22.0 ACCIDENTS AND MALFUNCTIONS

PACIFIC NORTHWEST LNG - ADDENDUM TO THE ENVIRONMENTAL IMPACT STATEMENT

22.3 RESPONSES TO THE OUTSTANDING INFORMATION REQUESTS

Figure 22-2 Public Short Term Exposure Limit (2.37 kW/m²) under an Emergency Flaring Event

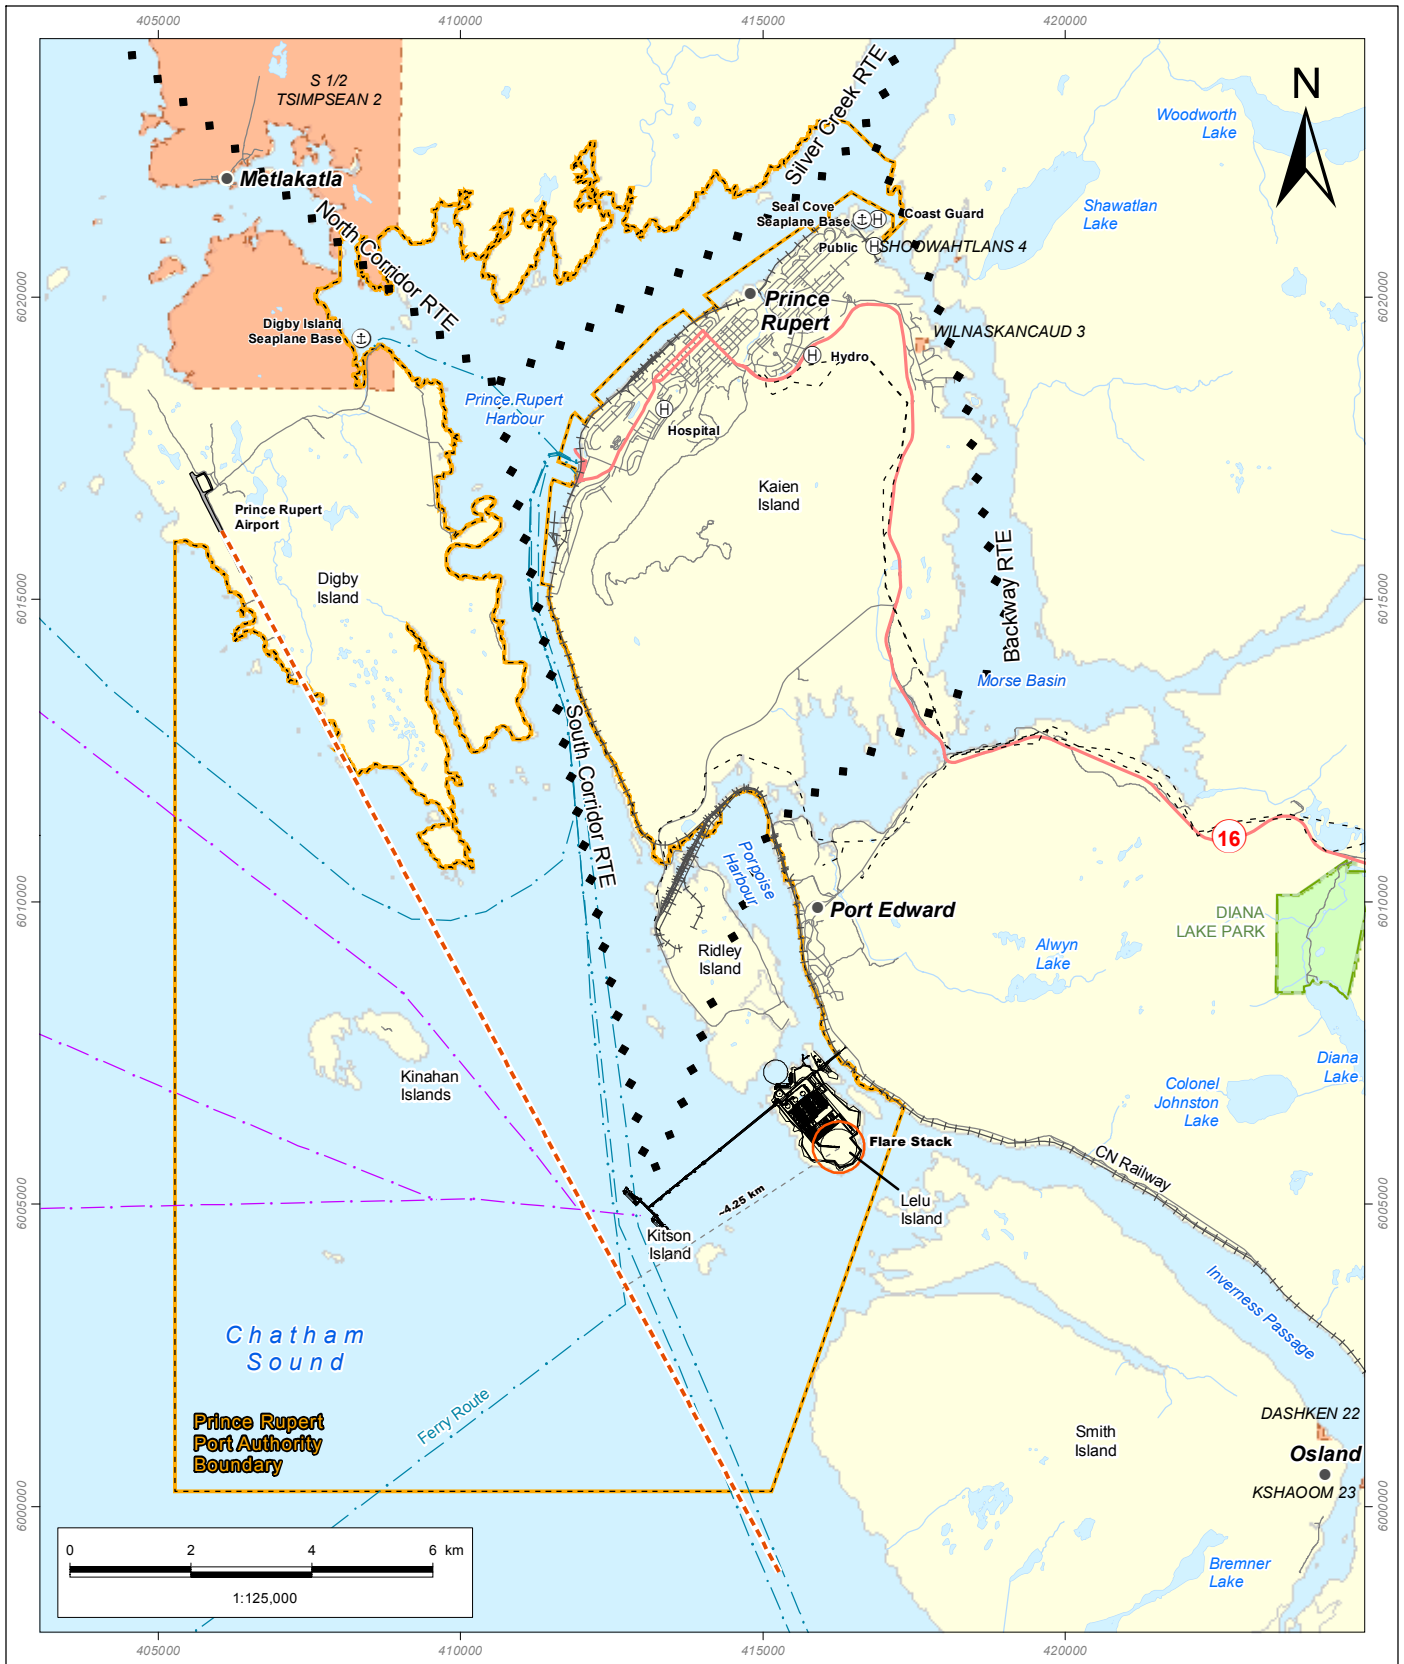
Transport Canada: *The flare tower is on or right beside a regularly used flight path for floatplanes and helicopters. The same radius used for effects on the ground by the flare would have to be considered as a "bubble" (i.e., in three dimensions surrounding the flare). The "Flammable Hazard Zone" depicted in Fig 22-1 of the EIS shows this zone intersects the route of small aircraft flying to and from the south from Porcher Island and along Inverness Passage. Update your assessment of effects to air navigation from emergency flaring based on this information. In your assessment, consider including references to any studies published in regards to interactions between small aircraft and flare towers, as well as communications with the airport and seaplane base operators to date.*

Based on these results, the Public Short Term Exposure Limit (2.37 kW/m^2) will appear as a sphere with a radius of 413 m from the centre of the flame (Figure 22-2). Under emergency flaring events, the effective height of the flare stack will be the sum of ground level at the base of the stack, stack height, half of the flame height, and the radius of the sphere [total height 641 metres above sea level (m asl)].

FIGURE NO:
22-4

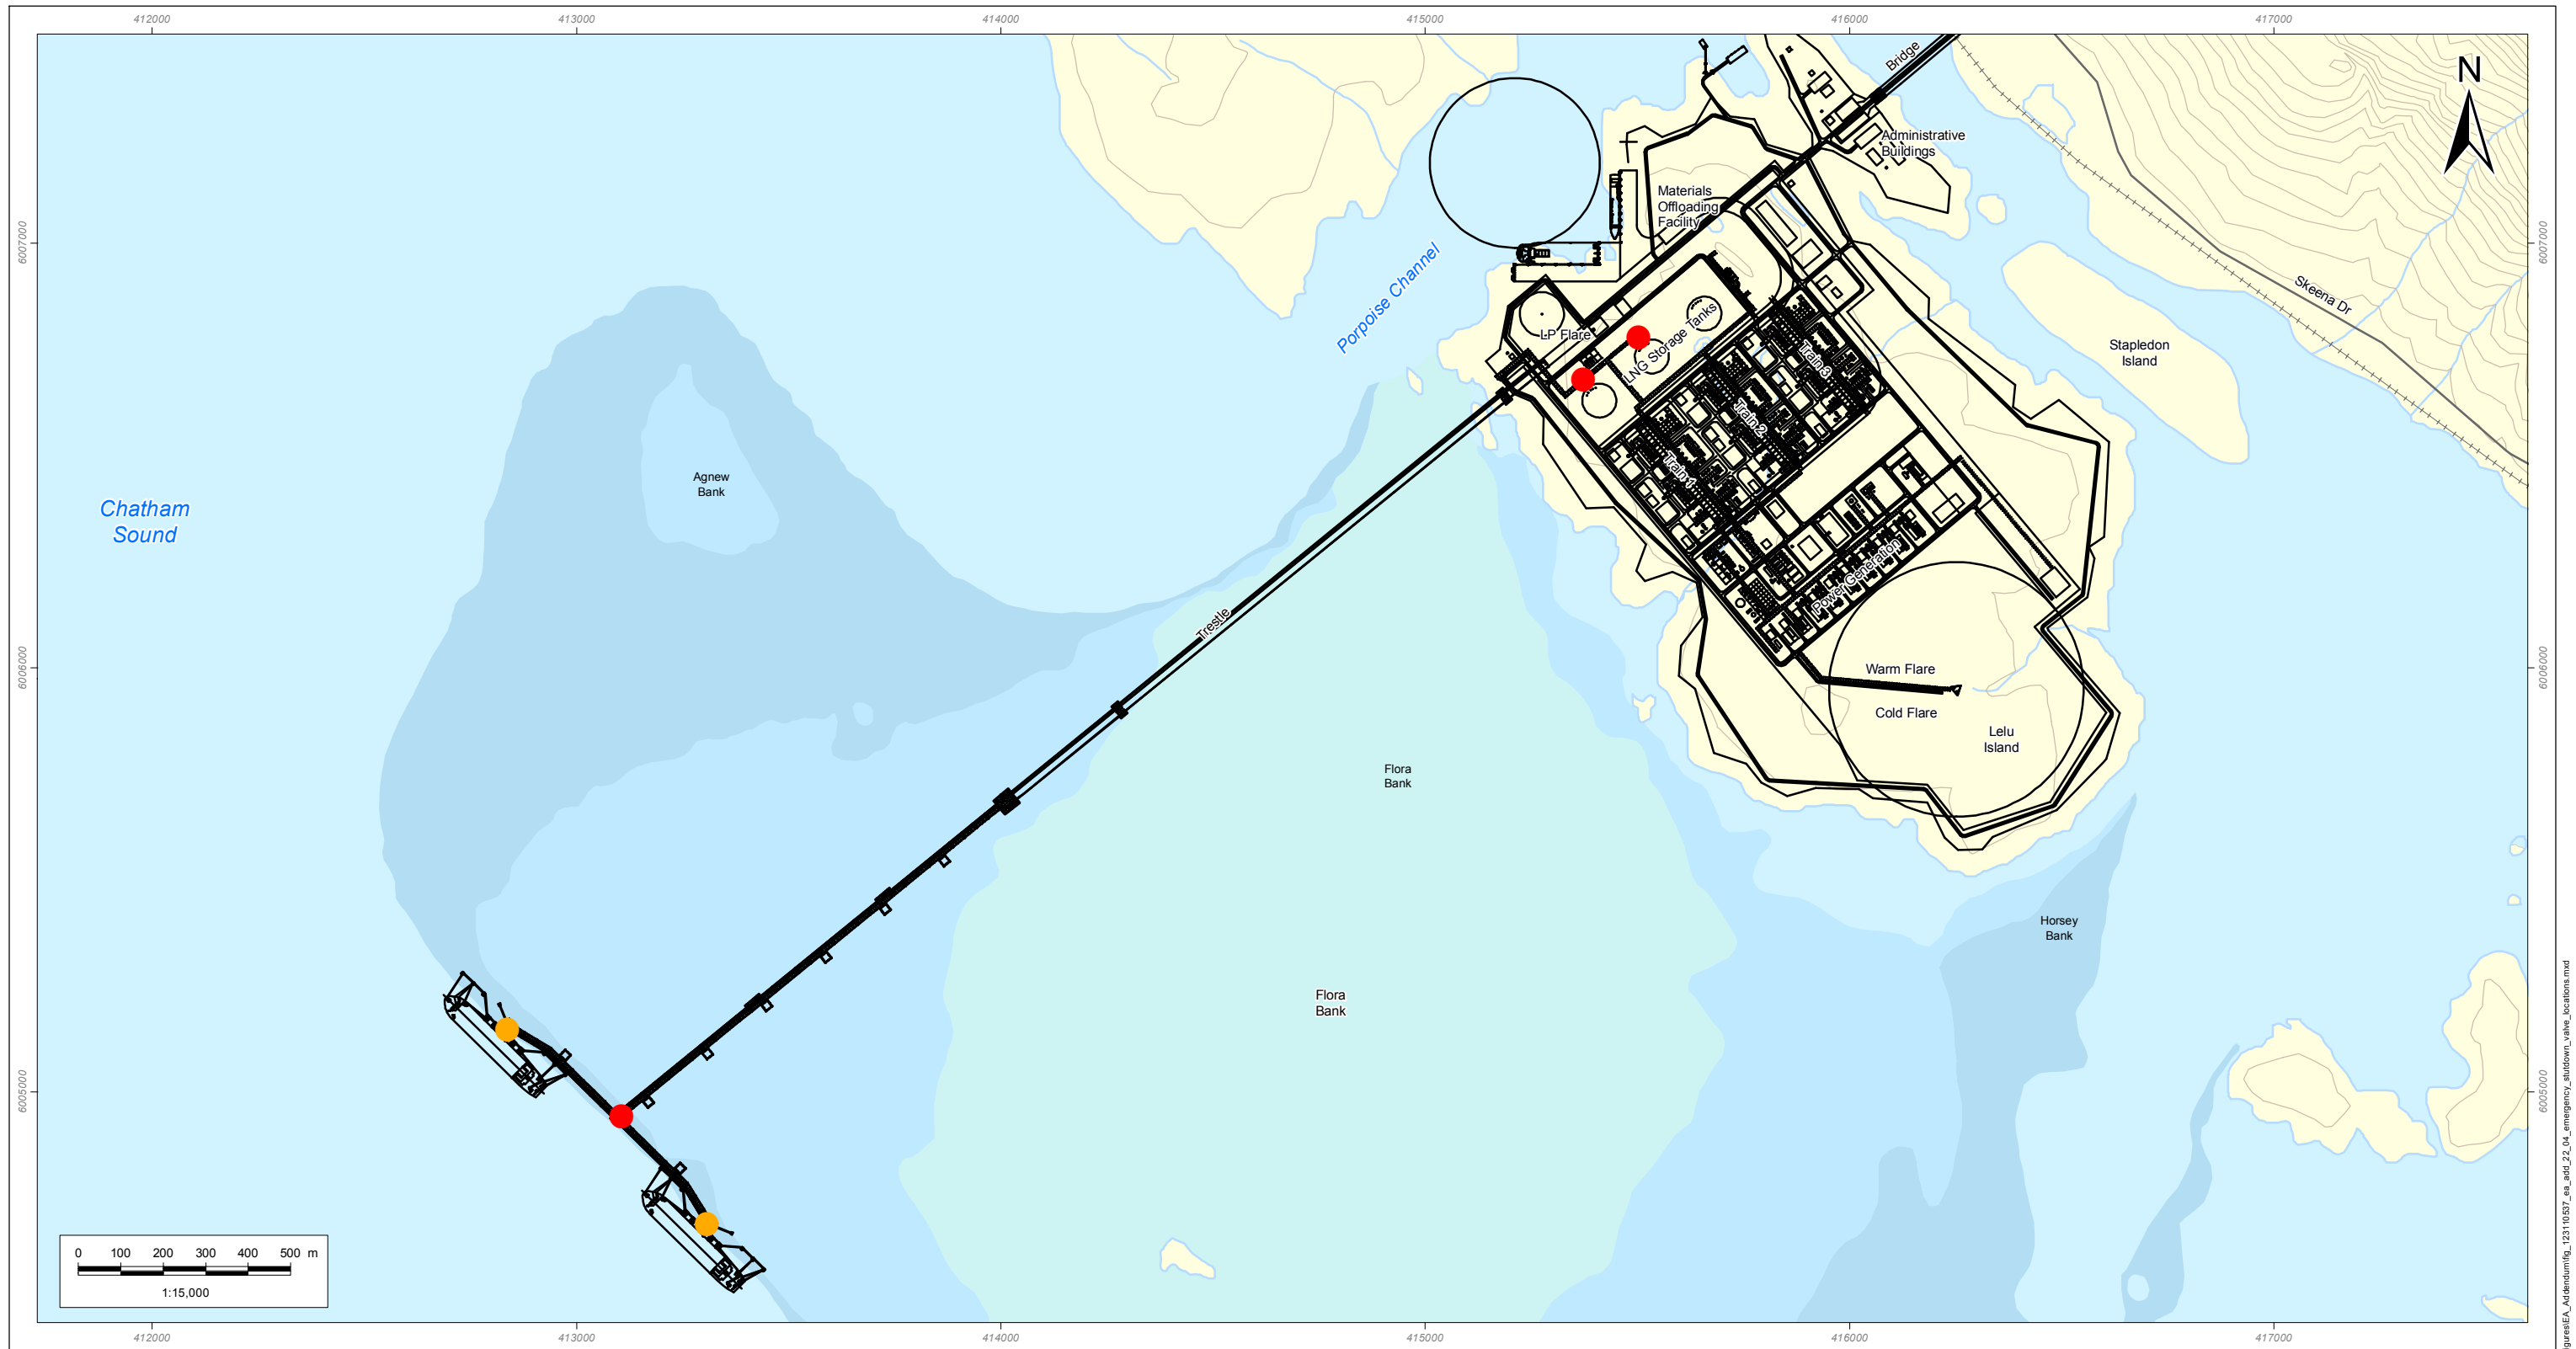
Transport Canada: *The scenario presented by the proponent would be a vessel or barge hitting the trestle at right angles to the pipe with a full or partial breach. It is unclear from the proponent's response whether the valves in question can shut off the flow at the pipe junction where the pipe goes from land to trestle. Do the volumes and times indicated in the memo apply to this scenario? If not, please indicate what they are. Also indicate where the likely location of the valves is including valves to the land on the trestle at the loading platforms.*

The volumes and times indicated in the EIS do apply to a scenario where a vessel strike to the trestle results in full breach. Volumes would be less for a partial breach. A number of emergency shutdown valves for the cryogenic line will be installed off-shore on the marine terminal, and on-shore near the LNG storage tanks (see Figure 22-4).
